RESPONSE TO COMMENTS

DRAFT ENVIRONMENTAL ANALYSIS

Advanced Clean Fleets Regulation

**Released April 17, 2023
to be considered at the
April 27, 2023 Board Hearing**

Figure 1: Projected Statewide ROG Tank-to-Wheel Emissions, Legal Baseline and Proposed ACF Regulation

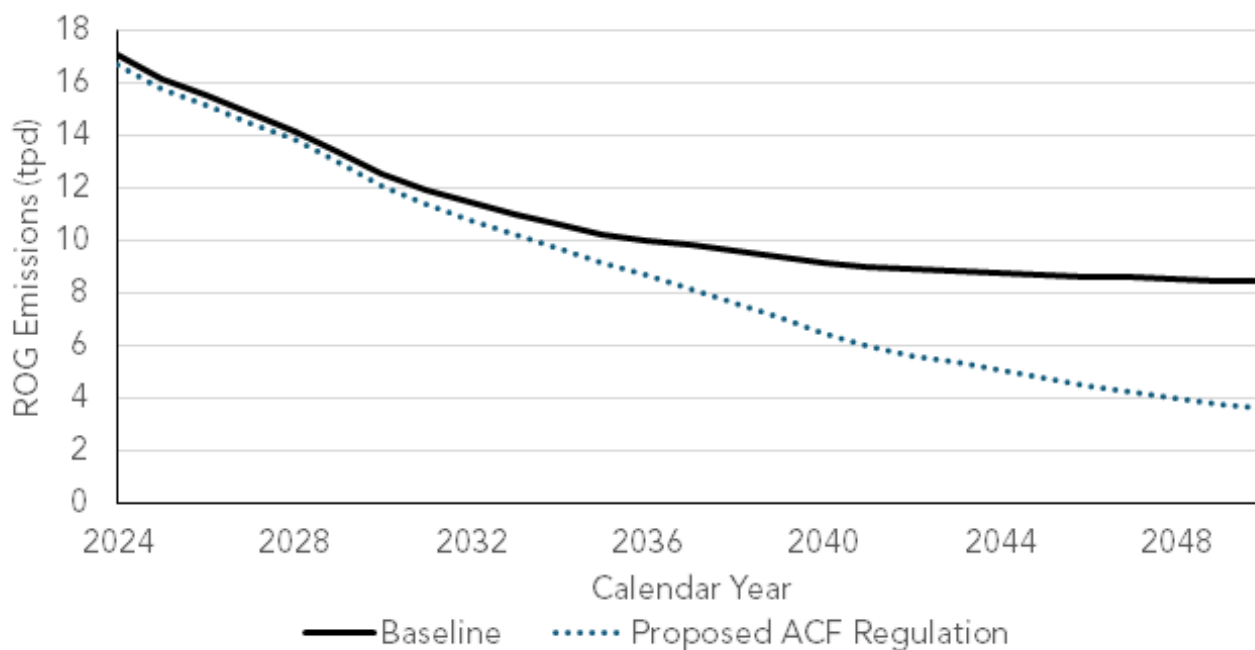
222-1: The commenter states "The draft EA does not contain an analysis or quantification on the reactive organic compounds (ROC) emissions as a result of the project. The Air Quality section includes an analysis on the PM_{2.5} and nitrous oxides (NO_x) but is missing analysis on ROC emissions, as can also be seen in Figure 4 and Figure 5. As a comparison, the draft EA for the 2022 Scoping Plan Update includes a NO_x and ROC emissions analysis that can be summarized in Table 4-3 of the draft document. The only reference to ROC in the EA for the Advanced Clean Fleet Regulation is found in Page 38 (missing its acronym but spelled out)."

Response: ROCs or reactive organic gases (ROG) emissions were initially omitted from staff's analysis as heavy-duty vehicles are not a significant emitter of these emissions. In response to these comments, staff have added an analysis showing ROG emissions in the baseline and under the proposed regulation. Staff's analysis shows the regulation is expected to result in a net reduction in ROG emissions as shown in Figure 1.

Figure 1. Vehicle Cycle Emissions from Class 8 Sleeper Cabs²³

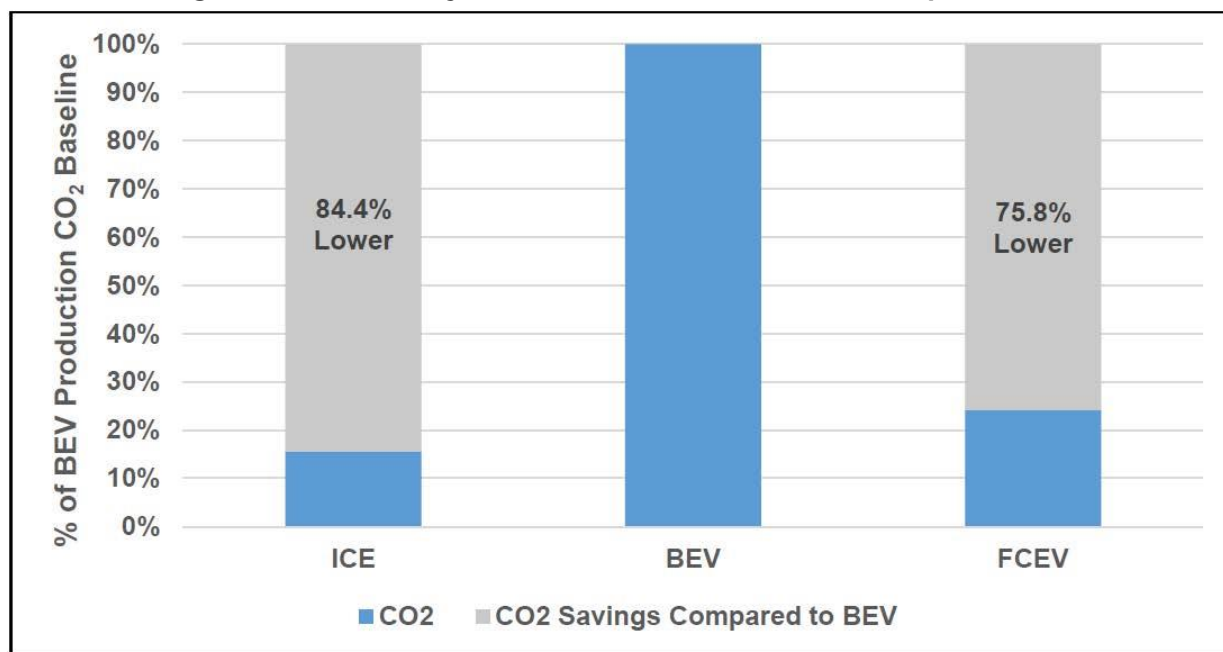
Additionally, the GHG emissions associated with vehicle production should be accounted for in the analysis. This is especially important for ZEV technologies, which have components (i.e., batteries) that generate significant additional emissions during vehicle production. A recently published study by ATRI analyzed the life-cycle emissions of a Class 8 Sleeper Cab vehicle and found that the vehicle production emissions for BEVs to be ~6 times higher than the corresponding ICEV counterpart (**Figure 1**).²¹ CARB has claimed in the Advanced Clean Cars II (ACC II) Response to Comments (RTC) that “the emission benefits from the use of these materials (e.g. battery and vehicle materials) in BEVs would ultimately offset the emissions from combustion of gasoline, diesel, and other fossil fuels from the development and use of these battery materials resources.”²² However this argument is unfounded. Accounting for the vehicle cycle emissions could potentially change the conclusions of CARB’s analysis and therefore must be assessed in order to understand the full environmental impacts of each technology.

While the ISOR estimated the reductions in tailpipe GHG emissions from the proposed ACF regulation, it fails to fully quantify the changes in upstream (well-to-tank) GHG emissions or the potential increases in vehicle cycle emissions that would occur with the implementation of this proposal. CARB must fully assess the GHG emissions impact that this regulation could have on the global carbon stock. Any assessment that does not recognize the full life-cycle GHG impacts misrepresents the actual environmental effects of the proposed regulation and would lead to factually incorrect conclusions that undermine any rationale for adoption of the proposed rule. Inclusion of the life-cycle emissions would allow for a better pathway to achieve the emission reduction objectives.

Figure 2. Capacity Analysis from CEC's EDGE Model⁴⁵ (dark red indicates no available additional capacity)

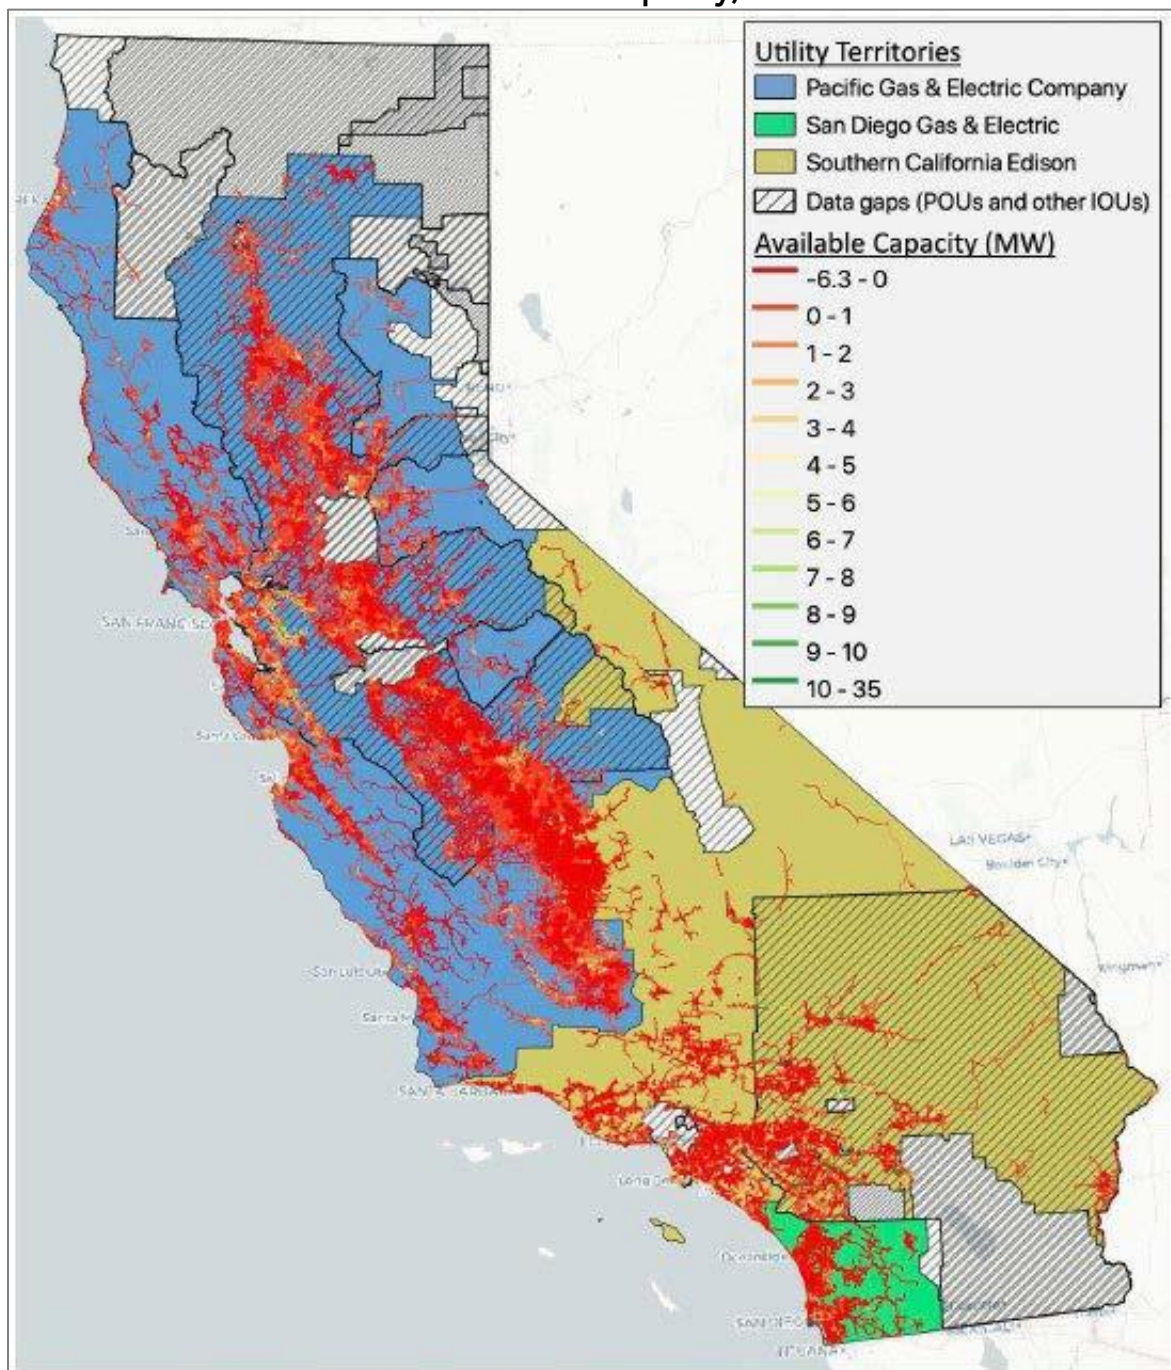
As noted in the quote above, the readiness of utilities to install new capacity must be assessed before asserting that the grid is able to handle the capacity EVs (especially heavy-duty EVs) will require.⁴³ The Capacity Analysis from California Energy Commission's (CEC) EDGE Model (**Figure 2** below, obtained from Page 49 in the Final ACC II EA⁴⁴) shows the grid has no additional capacity to add electrical load for charging EVs in most circuits. You

Figure 3. Capacity of circuits to integrate additional loads⁴⁶

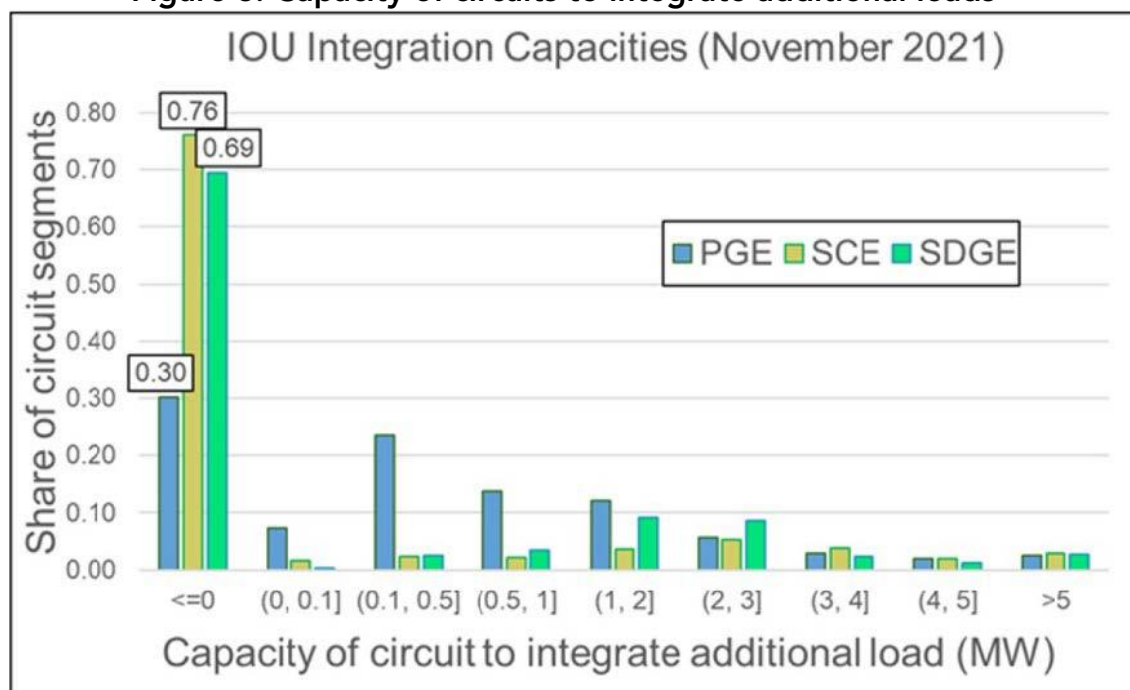
can see this in numerical terms in **Figure 3** (obtained from Virtual Medium and Heavy-duty Infrastructure Workgroup Meeting - Electricity and the Grid on January 12, 2022), which details the capacity of circuits to integrate additional load. This figure illustrates that 30% to 76% of circuit segments have no capacity to integrate additional load. Thus, no appreciable charging capacity can be added to most of these circuits without the expenditure and time for additional construction of needed transmission and distribution infrastructure.

Figure 4. ACC II EA Projected 2030 Statewide Plug-in EV Charging Load for Intraregional Travel of 8 Million LD ZEVs in EVI-Pro2⁵³

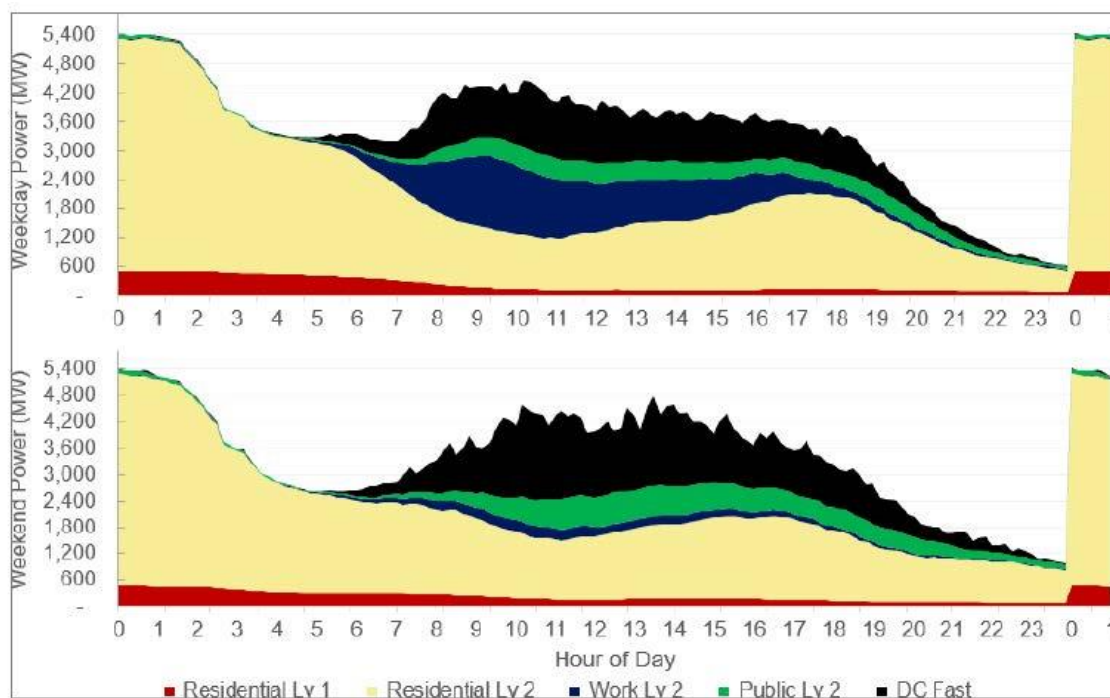
CARB must assess the level of infrastructure upgrades that would be required to support the peak load under these scenarios and whether it is feasible to upgrade the grid infrastructure to meet the demand within the timeframe of the Proposed Project. A representative from an energy utility commented during the March 10, 2022 public workshop that their 10-year planning window may need to be expanded to 15 years. Long lead items such as high-scale transmission can take upwards of 7-10 years to build, while distribution infrastructure for individual HDV projects require a minimum of 4 months of utility construction and can take 18-24 months to complete overall.⁵¹ Given that 1.5 million Class 2b-8 ZEVs would need to be deployed statewide by 2048 and the phased-in fleet transition begins in 2024, there seems to be too little time to complete these necessary upgrades.⁵²
